DUANE ARNOLD ENERGY CENTER

AMENDMENT TO FACILITY OPERATING LICENSE

Amendment No. 151
License No. DPR-49

ATTACHMENT TO LICENSE AMENDMENT NO. 151

Sodium Pentaborate Solution Volume
Concentration Requirements
FIGURE 3.4-1

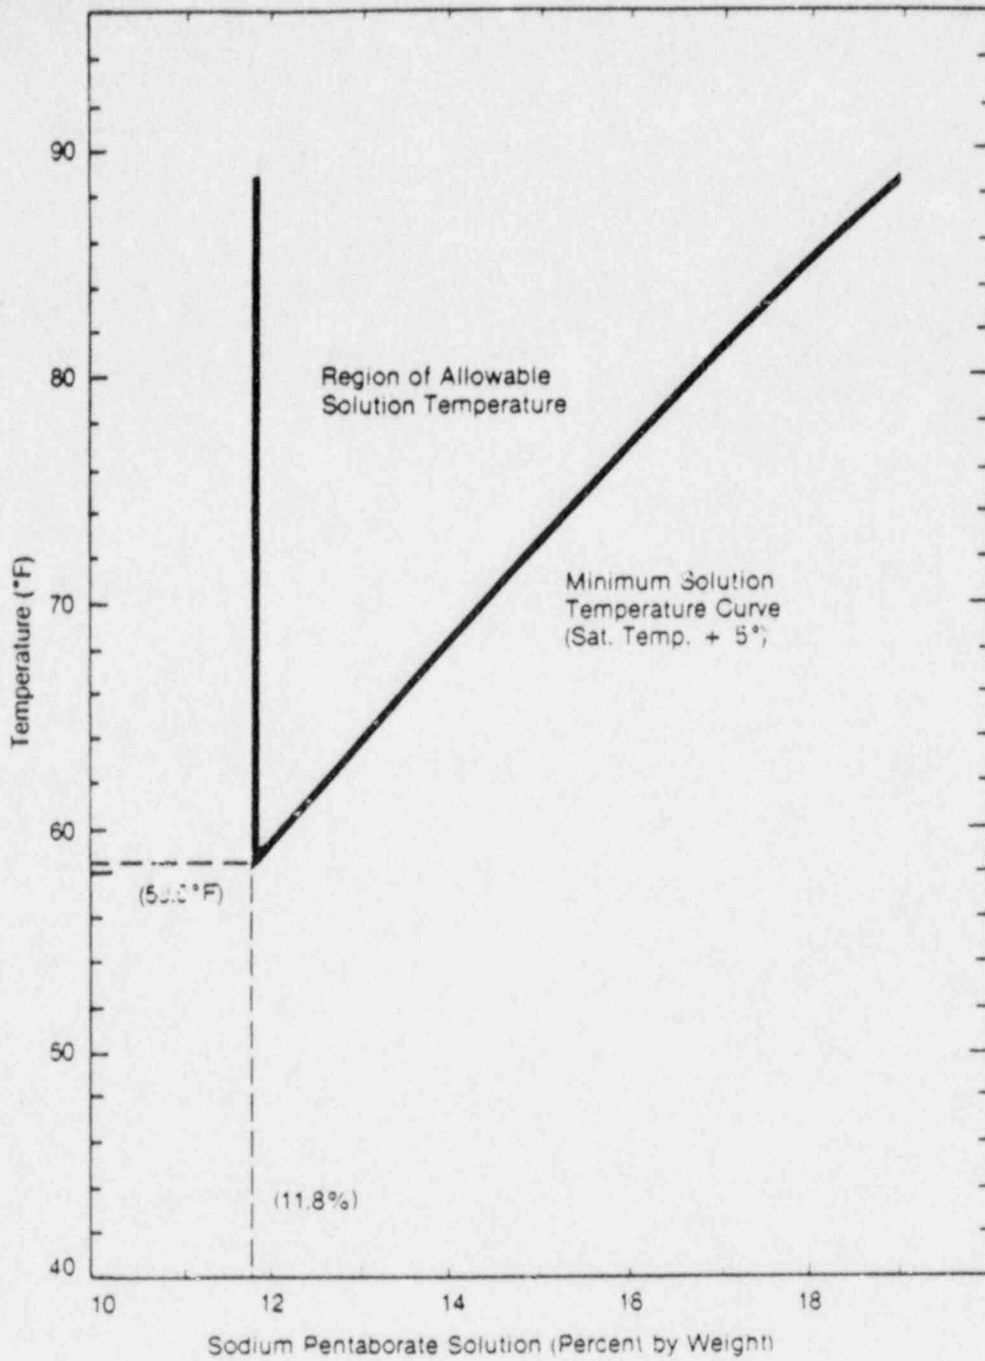
A minimum quantity of 2500 gallons of solution having a 11.8 percent sodium pentaborate concentration, or the equivalent as shown in Figure 3.4-1, will ensure that both the SLCS design basis (11.8%) and ATWS (11.2%) shutdown requirements are met. The maximum net storage volume of the boron solution, as established by the overflow, is 3270 gallons.
